- 2. Adams-Shaw Subdivision; KPB File 2024-096**
Edge Survey & Design / Adams
Location: Scout Lake Loop Rd. & Big Horn St.
Sterling Area

**ITEM 2 - PRELIMINARY PLAT
ADAMS-SHAW SUBDIVISION**

| KPB File No. | 2024-096 |
| Plat Committee Meeting: | September 23, 2024 |

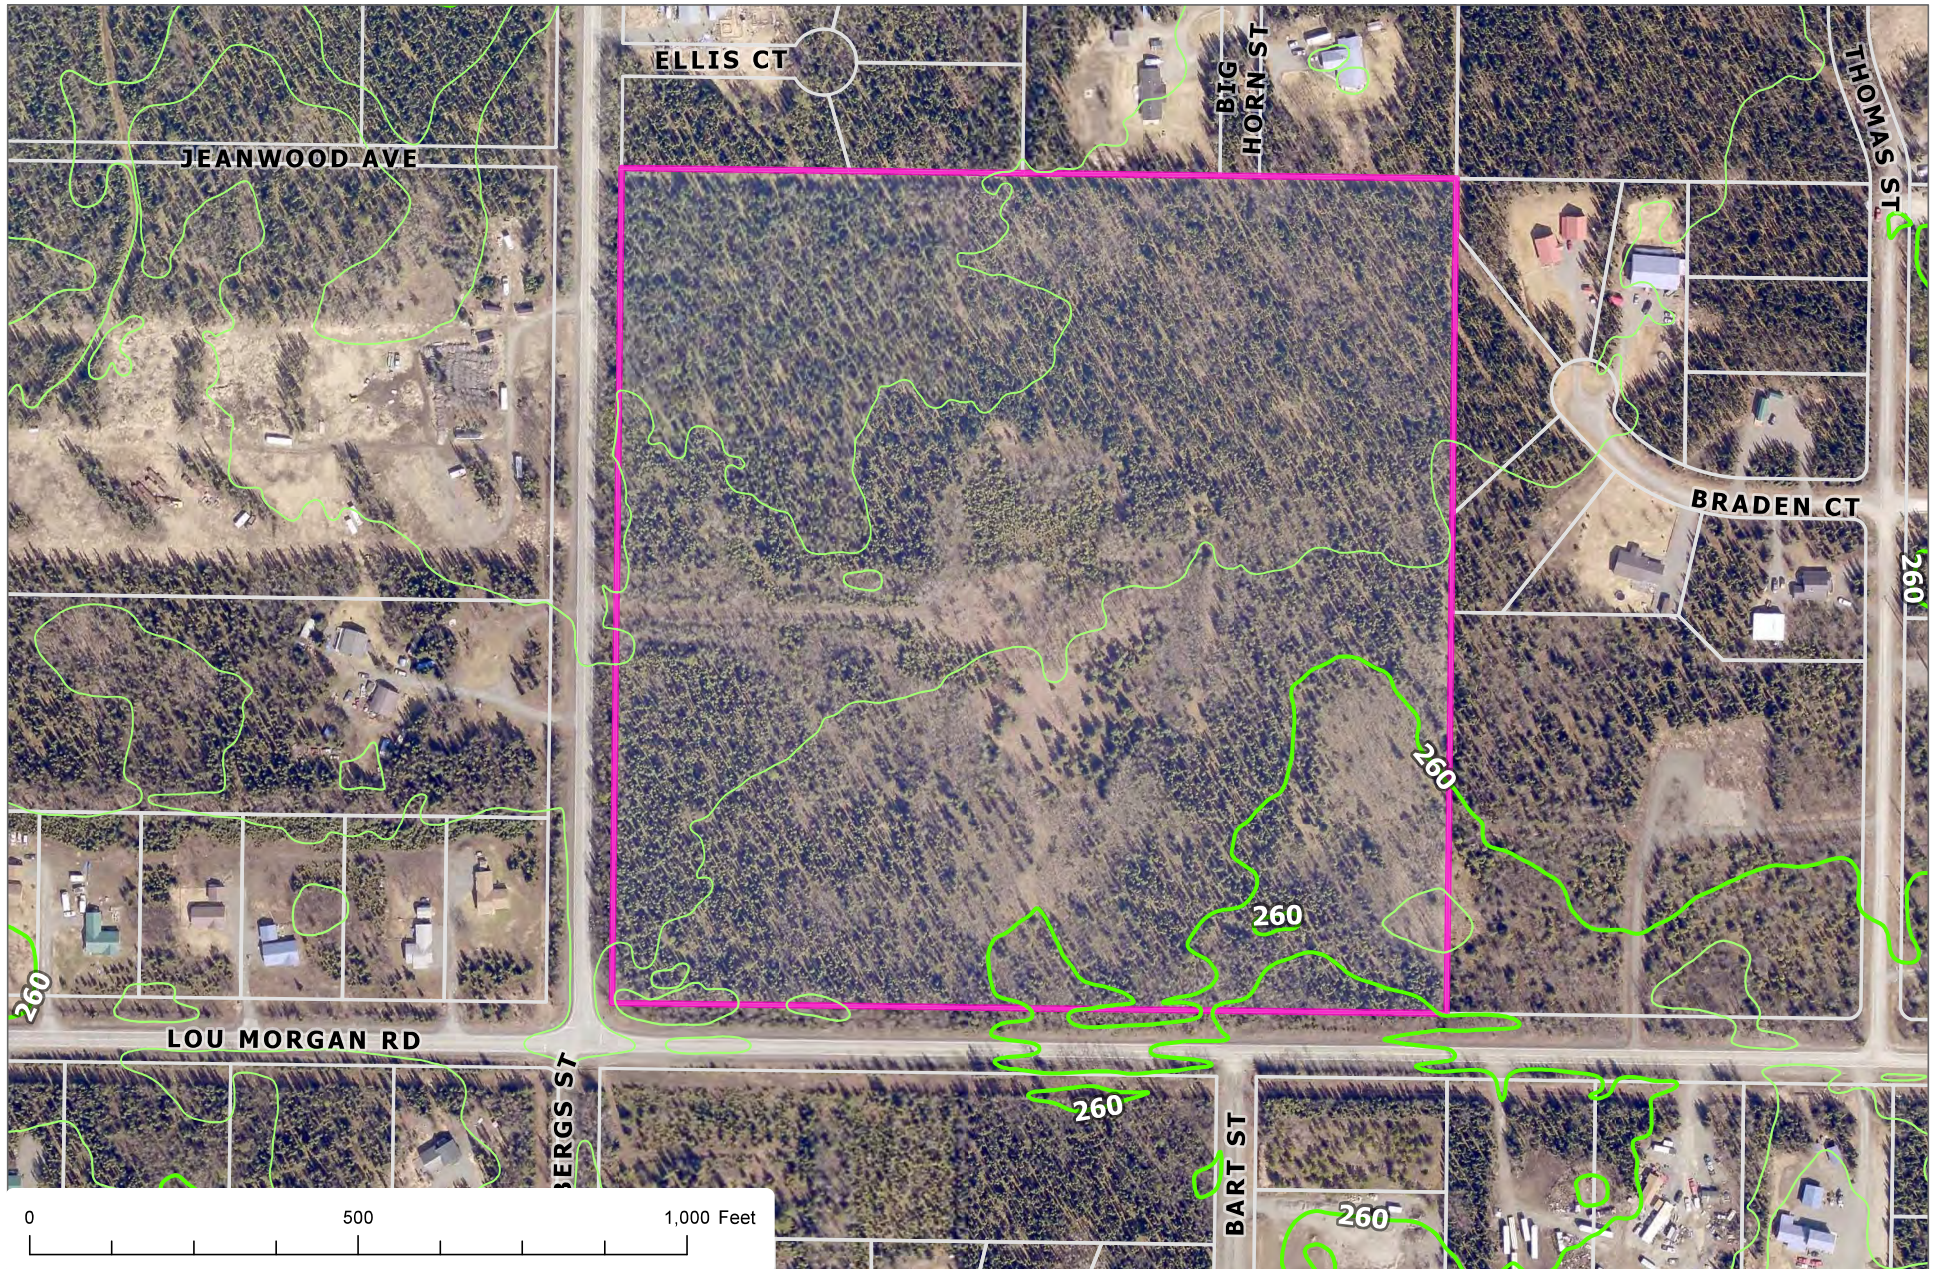
The proposed plat will extend the width of Scout Lake Loop Road with a 50 foot dedication on the west and south, resulting in a 100-foot complete right-of-way. Since Scout Lake Loop Rd is a State maintained road the Certificate of Acceptance needs to be to the State of Alaska. **Staff recommends** a Certificate of Acceptance be added in the name of the State of Alaska for Scout Lake Loop Road 50 foot dedication.

According to KPB GIS data Scout Lake Loop Road has a 66-foot section line easement, being 33-feet on either side of the section line. **Staff recommend** the surveyor verify the width of the section line easement and show said easement on the drawing.

Looking at the current layout of the plat, the 60' opening on the northwest corner, if this is to be a future road, it is too close to Jeanwood Ave and causing an offset intersection issue. Centerline to centerline distances shall not be less than 150', which this is 30 feet. ***Staff recommends*** either the surveyor request an exception to KPB 20.30.150 Street -intersection requirements or consider moving Lot 1 up against the north line and putting the 60' opening between Lots 1 & 2. This will create a centerline distance of greater than 150' and compliance with KPB 20.30.150(B).

The proposed plat grants a 15-foot utility easement adjacent to the rights-of-way and is noted on the plat and shown in the detail. KPB Code 20.30.060(D) only requires a 10' utility easement, it is the surveyor's choice to keep the 15' utility easement or reduce to the 10' utility easement.

Staff recommendation: Correct Road name to, “Scout Lake Loop Road.” on both sides
Verify and Indicate section lines easement on south line

Staff recommendation: Correct Ellis Street to Ellis Court to the north.
Label Lot 2, KN 99-93, to the east.
South parcel should be corrected to reflect Tract C1, KN 2013-33.
West-south parcel plat reference should be KN 2003-50.
Please remove the hyphen on the south-southeast parcel, “Tract A1.”
